Technical Note

Project: Stanmore Garden Village, Bridgnorth

Subject: Response to Shropshire Council's Key Consideration (Highways)

Tasley Garden Village Route Constraints

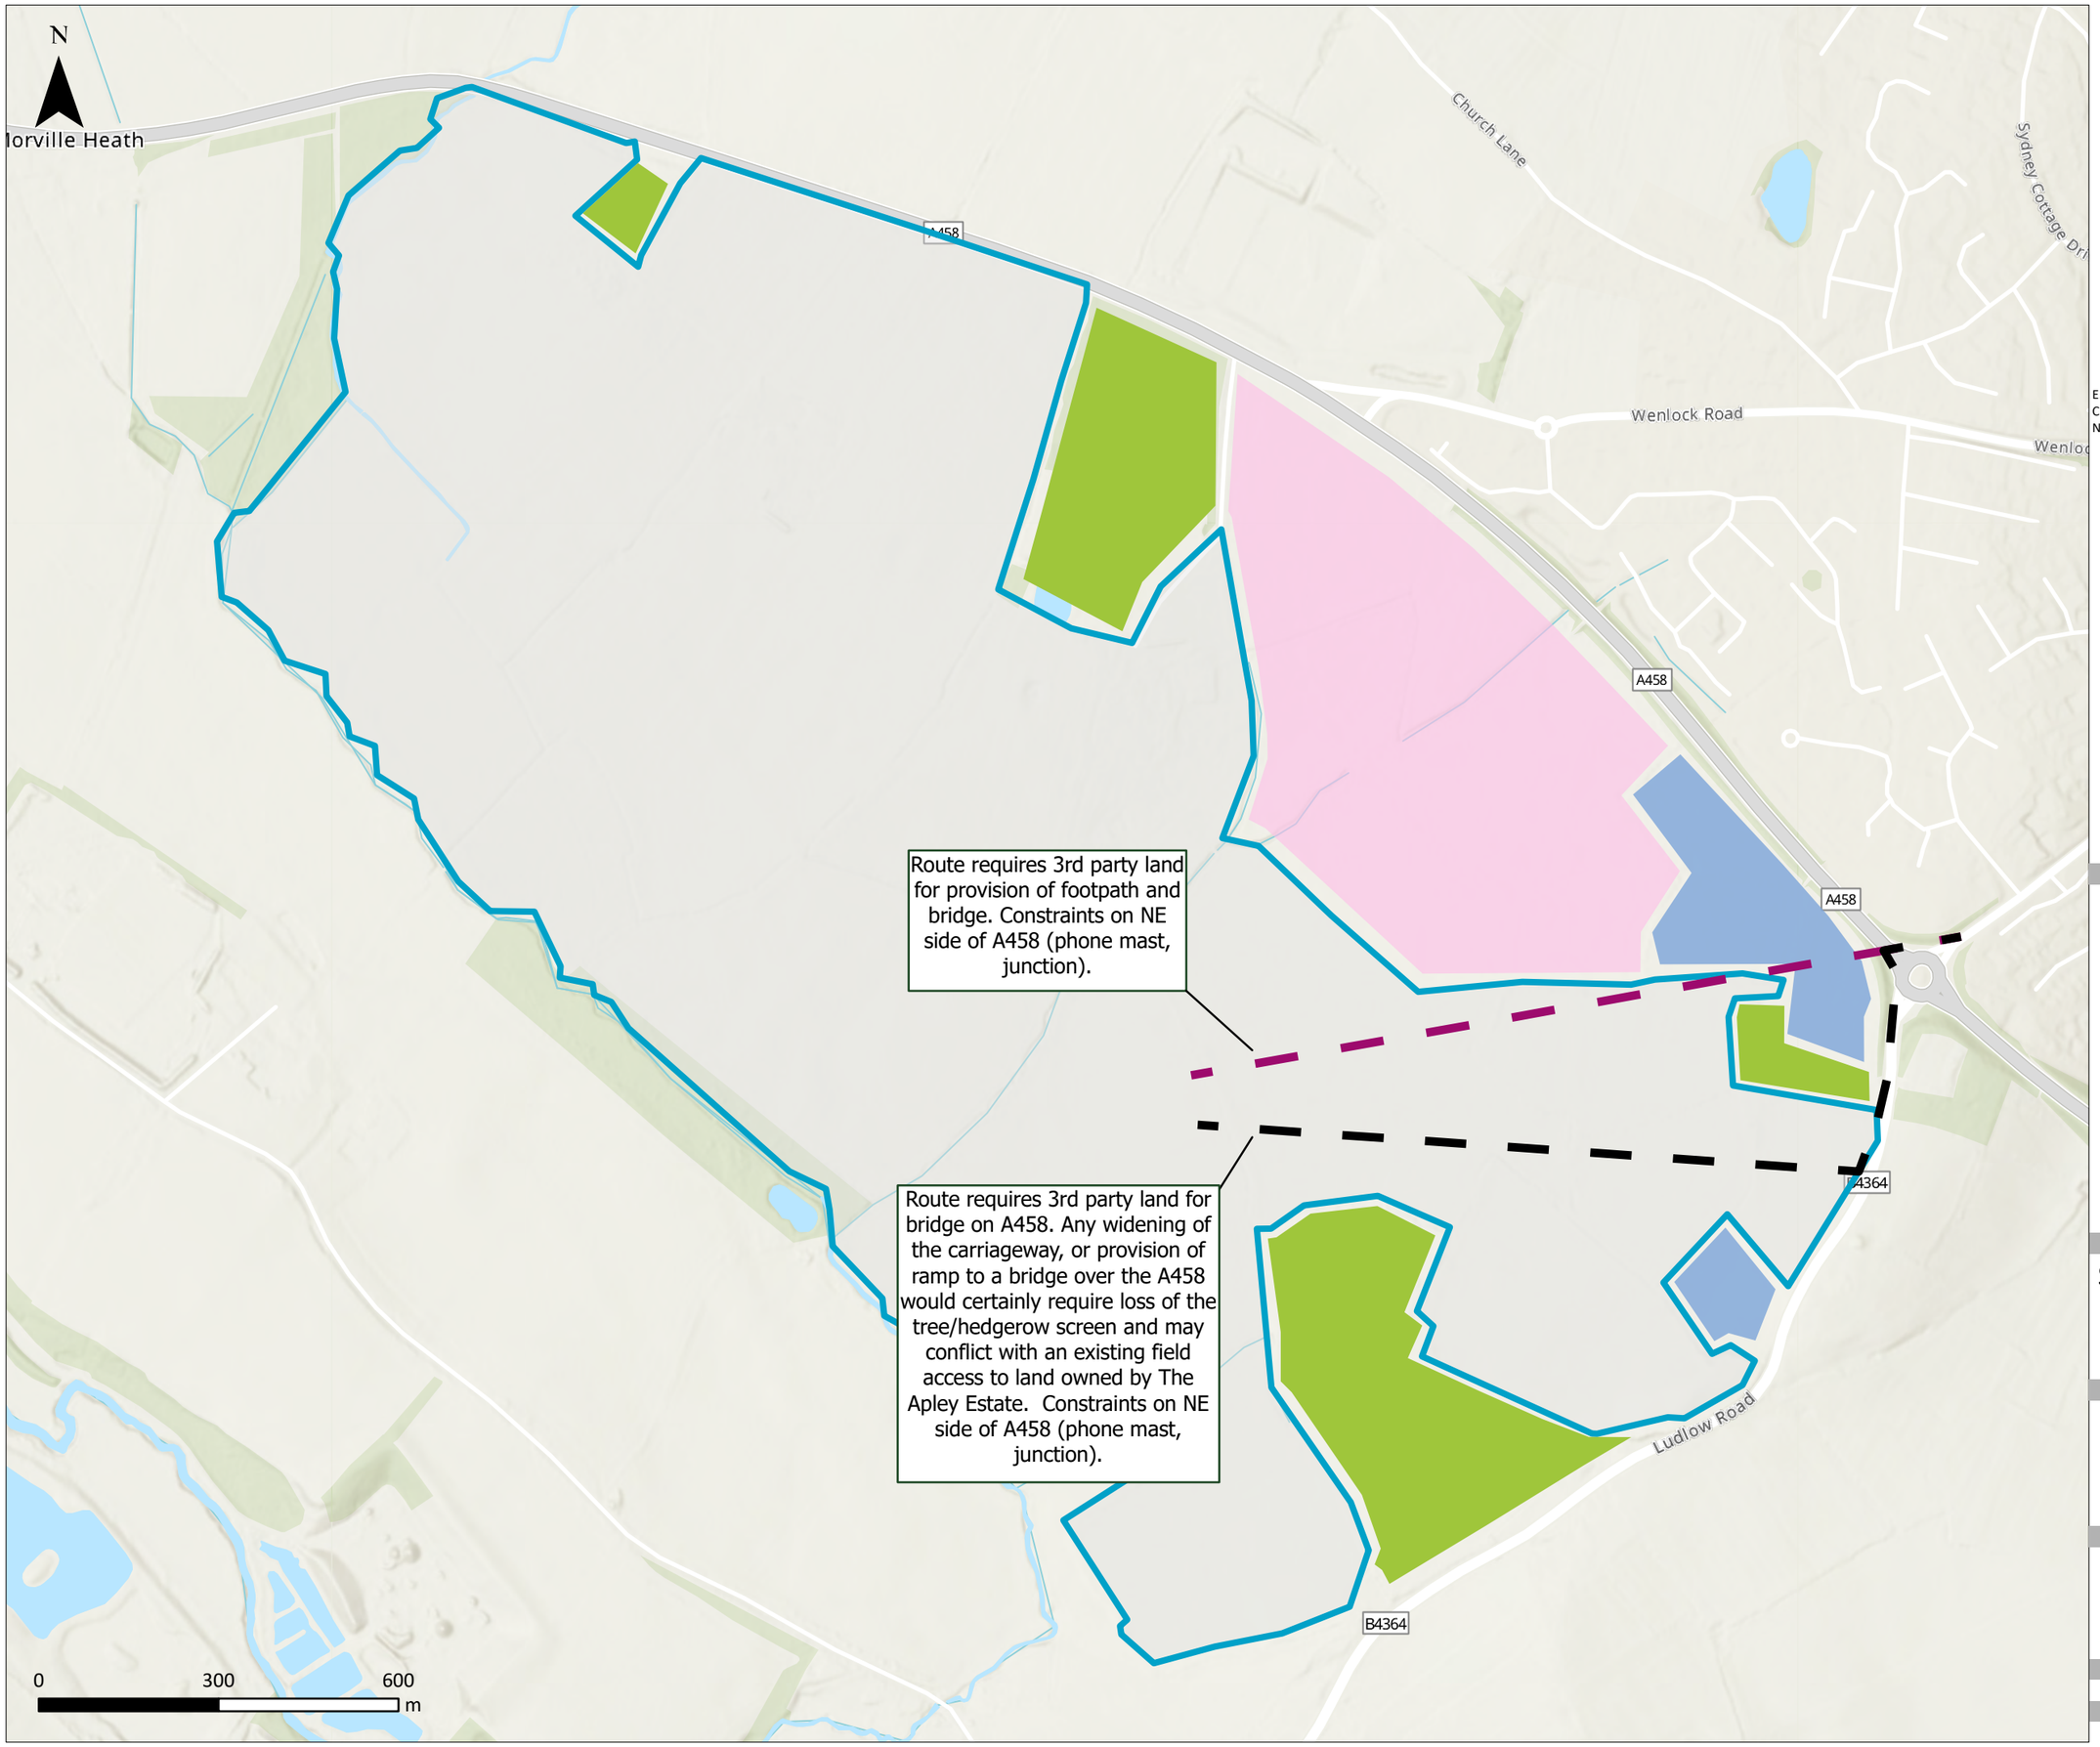
30	The land at the 'Garden Village' at Stanmore is separated from the built form of Bridgnorth by Hermitage Ridge. Necessary improvements to pedestrian and cycle facilities to create safe links between the site and the built form of Bridgnorth are essential in order to reduce the potential segregation between the existing settlement and the site. This would require careful consideration given the gradient and nature of roads and footpaths between Bridgnorth and the site.	Paragraph 108 in NPPF states that "*In assessing sites that may be allocated for development in places, or specific applications for development, it should be ensured that appropriate opportunities to promote sustainable transport modes can be – or have been – taken up, given the type of development and its location".* Opportunities to provide safe links between Stanmore Garden Village and Bridgnorth Low Town have been identified within the promotional documentation and supporting technical work. To link Stanmore Garden Village to Bridgnorth Low Town, it is proposed to provide pedestrian and cycle links across Hermitage Ridge along new and existing Public Rights of Way (PRoW). Following a site visit, it is considered feasible to provide a new DDA compliant route across Hermitage Ridge, under existing overhead

SC Key Consideration		PJA Response
		power lines, at a gradient of 1 in 20 and with limited or no loss of adjacent trees, into existing adjacent residential areas in Bridgnorth. This route, and the enhancements of other PRoW, will provide a traffic-free, direct, and safe link between Stanmore Garden Village and Bridgnorth Low Town. All of the land required to facilitate these improvements is owned by The Apley Estate and therefore is deliverable entirely without 3rd party land. In addition, The Apley Estate owns the land adjacent to the A458 and B4363 (Wolverhampton Road) and could upgrade and widen existing footways along both of these routes.
31	The land at the 'Garden Village' at Tasley is separated from the built form of Bridgnorth by the A458. Necessary improvements to pedestrian and cycle facilities to create safe links between the site and the built form of Bridgnorth are essential in order to reduce the potential segregation between the existing settlement and the proposed development. This would require careful consideration to ensure that the infrastructure provided is safe and attractive to pedestrians and cyclists.	For Tasley Garden Village, it is understood that a footbridge was stated by the promoter's consultants to be unnecessary and an 'at grade' crossing has been included within the proposals and consultation documentation to connect the site to Bridgnorth town centre. Within the Transport Issues Report (paragraph 3.4.3), it states that "*…the details of a potential footbridge crossing of the A458 adjacent to the site frontage could be considered in more detail if were considered necessary following discussions with the highways team*". SCC has advised that if this site was allocated, the development guidelines would state a pedestrian footbridge <u>would</u> be a necessary element of the proposal. Given the traffic volumes on the A458, an at grade crossing would likely provide a lower level of service than a well designed pedestrian/cycle bridge and would therefore be a compromised solution. The feasibility and safety of such an at grade solution would need to be carefully considered through the design process and engagement with the highway authority. There are concerns relating to the feasibility of providing a footbridge along the desire lines, and the linkages to it, as set out within the PJA review of the Tasley Garden Village proposals, and summarised below: • It is likely that a footbridge could not be delivered without use of third party land for construction (required land is within ownership of The Apley Estate who have declined to make it available). The ability to deliver a footbridge, which has been deemed as a necessary element of the proposal, is therefore in doubt. • The development proposals must facilitate both pedestrian <u>and</u> cyclist trips into Bridgnorth. A bridge to accommodate cyclists as well as pedestrians (3m width ramps and bridge deck) would not fit within highway boundary and therefore, cyclists would be required to cross at grade at the Ludlow Road/A458 roundabout. LTN 1/20: Cycle Infrastructure Design states that '*normal roundabouts with flared geometries and no additional cycle facilities are unsuitable for most people wishing to cycle and can pose a high risk even for experienced cyclists.*'

SC Key Consideration		PJA Response
		On this basis, it is concluded that without significant improvements to cycling facilities at this roundabout, in line with guidance set out in LTN 1/20, there is no safe route for cyclists to access Bridgnorth town centre from the site. • The ability to construct a bridge with ramps and footway on A458, is constrained by the existing earth bank and tree screen on the northern side of the carriageway. It is likely that retaining structures would be required following excavation, which may require third party land; it is likely the trees providing screening to housing on Harley Way and Campbell Close would be lost (see photo in **Appendix B**). In addition, within the promotional documents, the desire lines for both pedestrians and cyclists follow various PRoW. The ability to improve a PRoW depends on the agreement of any third party landowner. The Apley Estate control the PRoW that links to the A458 and will not be in agreement to any upgrade proposals. This will lead to a diversion of 300m to Ludlow Road before crossing the A458 (either via a bridge or at-grade crossing) to avoid further diversion. It is not considered that a diversion away from the desire lines would form an attractive route for pedestrians or cycles, and would also undermine any bridge proposals. A plan showing the ideal, and alternative routes is shown in **Appendix A.** The highway boundary data shows that along the site frontage between the Apley Land and retained part of Round Thorn Farm, and along the eastern boundary of the Apley Land there is between approximately 6m to 12m of highway boundary – the majority of this is trees/hedgerows, providing screening from A458. This narrows in width further south down Ludlow Road. Therefore, any widening of the carriageway, or provision of ramp to a bridge over the A458 would certainly require loss of the tree/hedgerow screen and may conflict with an existing field access (to land owned by The Apley Estates). If SCC regards a footbridge as a necessary part of the development proposals, but doubt exists as to its feasibility, it is considered that the promoter should be required to demonstrate how it intends to accommodate such provision at this early stage.
